TROJAN NUCLEAR PLANT

Operating License NPF-1
Docket 50-344
License Change Application 71

Licensee hereby requests an amendment to License NPF-1 to incorporate a change in the MODE 5 shutdown margin requirement.

Figure 1 Shutdown Margin Requirements and Availability for a Boron Dilution Accident at Trojan

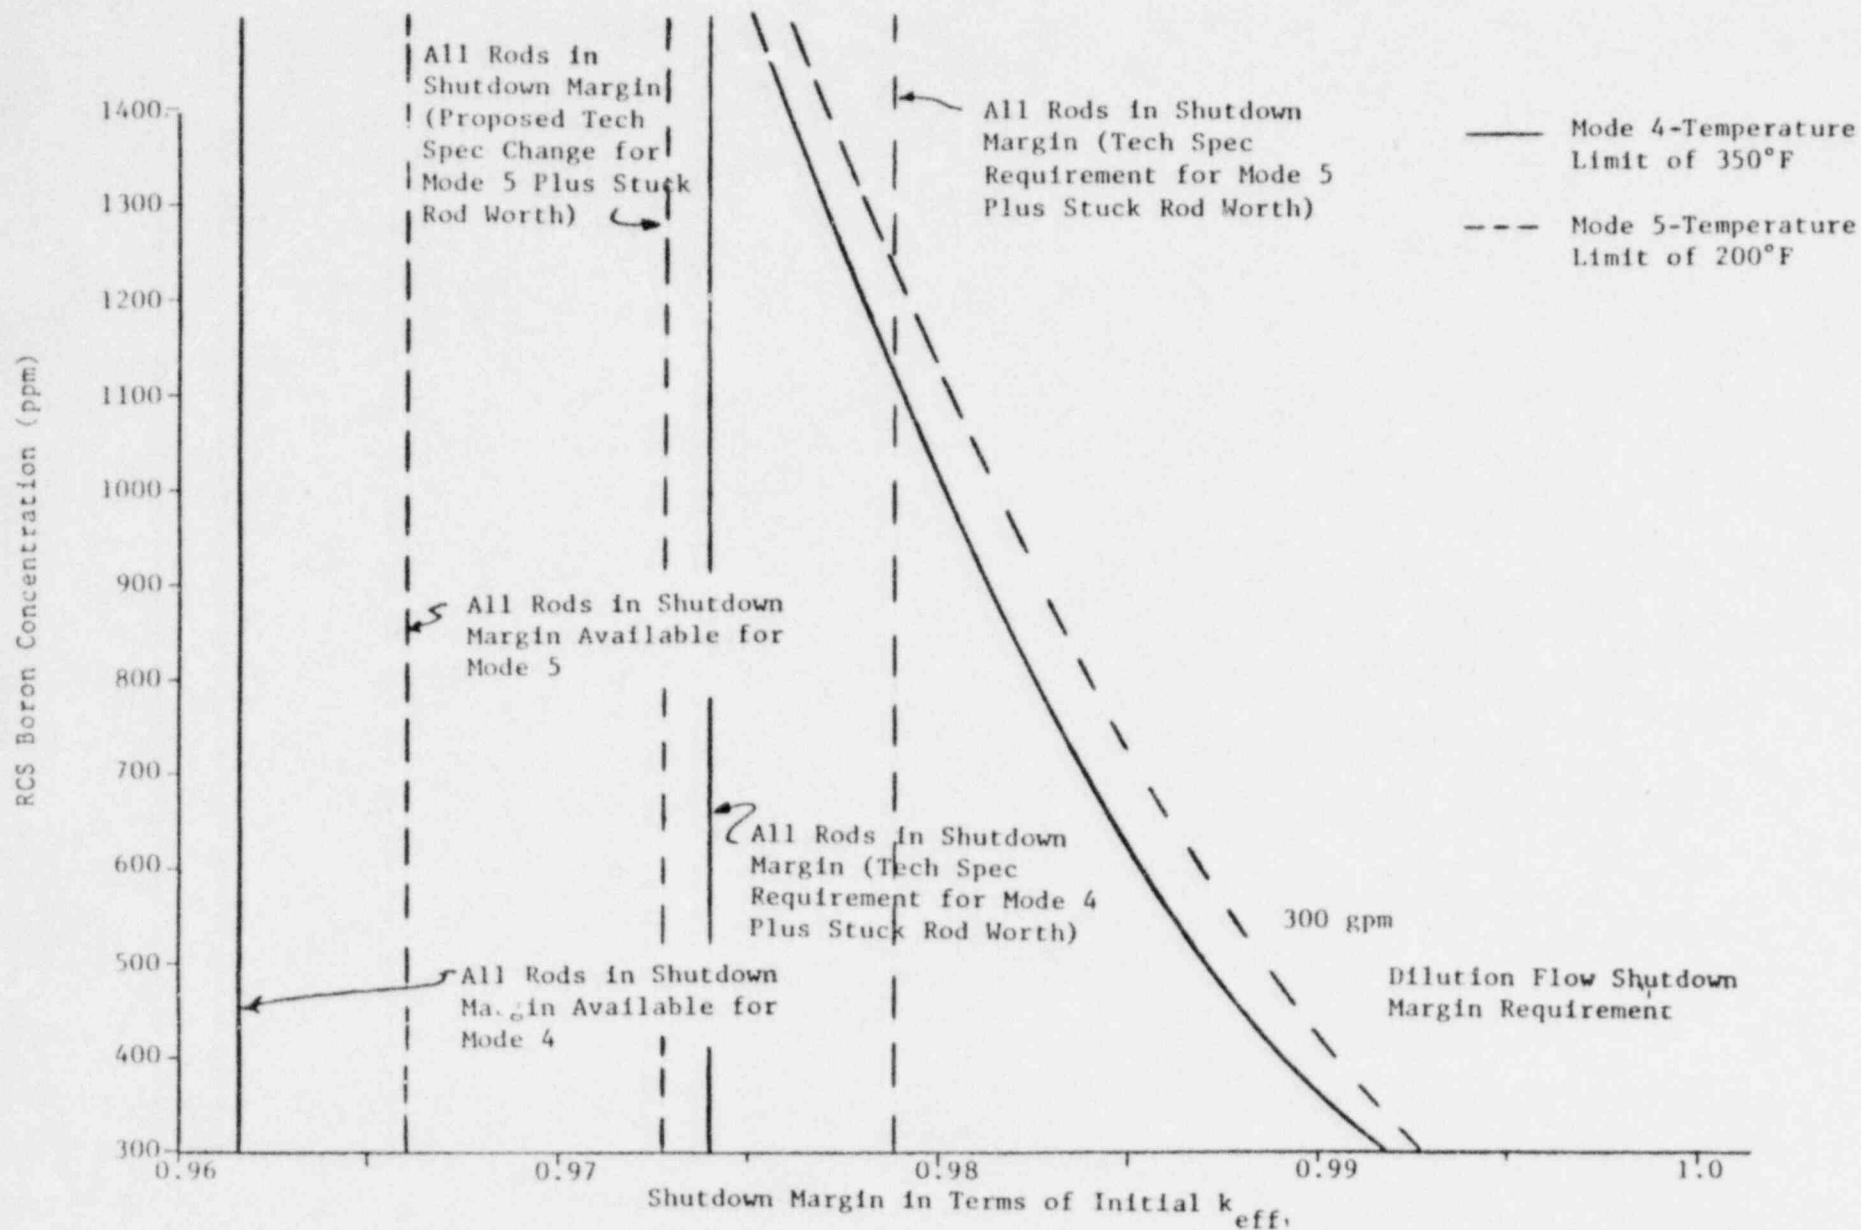
This License Change Application (LCA) incorporates a Technical Specification change to the MODE 5 shutdown margin. This Technical Specification change is in response to the NRC letter dated September 30, 1980 concerning the consequences of an inadvertent boron dilution event during MODES 4 and 5. The PGE analysis concluded that return to criticality due to a boron dilution event will not occur for the Trojan Nuclear Plant, as current available shutdown margins preclude this from happening (see Figure 1). However, the Technical Specification shutdown margin requirement plus stuck rod worth will not guarantee an adequate shutdown margin for a boron dilution event during MODE 5 operation. Therefore, PGE committed in its response to the NRC dated November 26, 1980 to submit this Technical Specification revision changing the MODE 5 shutdown margin from 1.0 percent $\Delta k/k$ to 1.6 percent $\Delta k/k$ to ensure that minimum shutdown margin requirements are met. This LCA modifies the Technical Specifications to complete this commitment.

Technical Specification 3/4.1.1.1, requiring a minimum shutdown margin of 1.6 percent $\Delta k/k$, applies to Plant operational MODES 1 through 4. Technical Specification 3/4.1.1.2 requires a shutdown margin of 1.0 percent $\Delta k/k$ and applies to MODE 5. This proposed Technical Specification revision consolidates these two Technical Specifications, eliminating Technical Specification and Technical Specification Bases 3/4.1.1.2 and increasing the MODE 5 minimum shutdown requirement to 1.6 percent $\Delta k/k$. Shutdown requirements for MODES 1 through 4 remain unchanged. Proposed Technical Specification Surveillance Requirement 4.1.1.1.1.e applies to MODES 3, 4, and 5 to properly consolidate the MODE 5 surveillance requirements. In addition, proposed Technical Specification Bases 3/4.1.1.1 is amended to describe the bases for the boron dilution event minimum shutdown margin requirement as the limiting condition for MODE 5 ($T_{avg} < 200^\circ F$). The proposed Technical Specifications, including changes in the Index, are shown in Attachment A of this LCA.
